PART NUMBER	DESCRIPTION	SHIPPING WEIGHT (KG)
UVP036	VRLA EXTERNAL BATTERY PACK (EBP) 2*3PCS 36V (3AH BATTERIES) CHASSIS, BATTERIES, AND RAIL KIT INCLUDED, FOR 1KVA UPS ONLY	29.40

EXTERNAL BATTERY PACK:  
 UVP036

EXTERNAL BATTERY PACK UVP036											
CUSTOMER DRAWING											
REVISED TIME: UVP036/01											
REVISED TIME: UVP036-DC/01A											
UNLESS OTHERWISE SPECIFIED, DIMENSIONAL TOLERANCES ARE MM (IN)											
THIRD ANGLE PROJECTION											
UVP036-DC											
SHT 1 OF 2

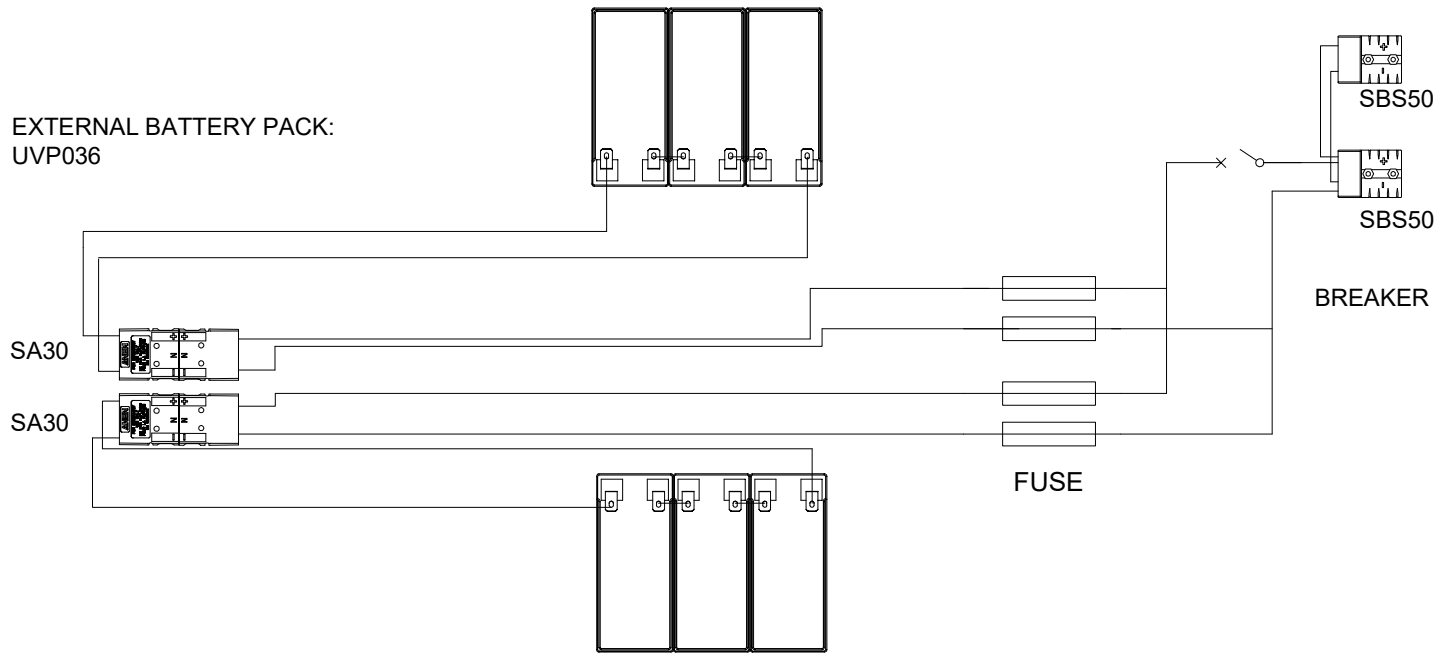
WE ASK THAT YOU CHECK AGAIN THE SUBSTITUTIONS AND WITH THE CLIENT THE USE AND THE PROPER WEIGHT OF THE BATTERY PACK AS IT MAY AFFECT THE OUTPUT.	
FILE	
EXTERNAL BATTERY PACK UVP036	
CUSTOMER DRAWING	
REV NUMBER AND UVP036-01	UVP036-DC/01A
UNLESS OTHERWISE SPECIFIED, DIMENSIONAL TOLERANCES ARE IN (MM)	N/A
THIRD ANGLE PROJECTION	UVP036-DC
DATE	08/17/2022
SCALE	VARIOUS
SHEET	1 OF 2
